MODIFICATION INSTRUCTIONS

KODAK MULTILOADER 700/700 PLUS SIDE-BY-SIDE KIT

MODIFICATION No. 2

figure 1-1

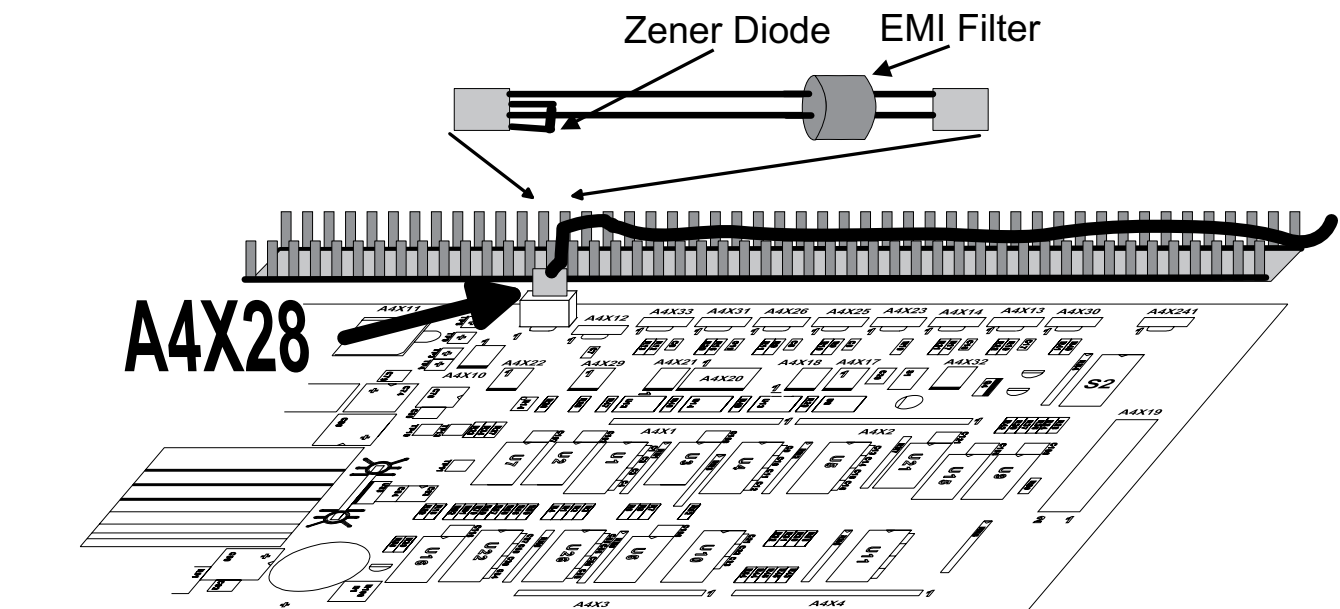
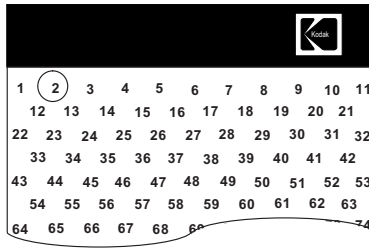
1. Switch off the SBS and all connected devices.
2. Remove cover of the SBS.
3. Open the cable duct near the PCB A4.
4. Disconnect connector A4X28 at the PCB A4 and connect it to the cable delivered with Modification Kit

5. Store the cable in the cable duct.
6. Close the cable duct.
7. Circle Mod 2 at the modification label.
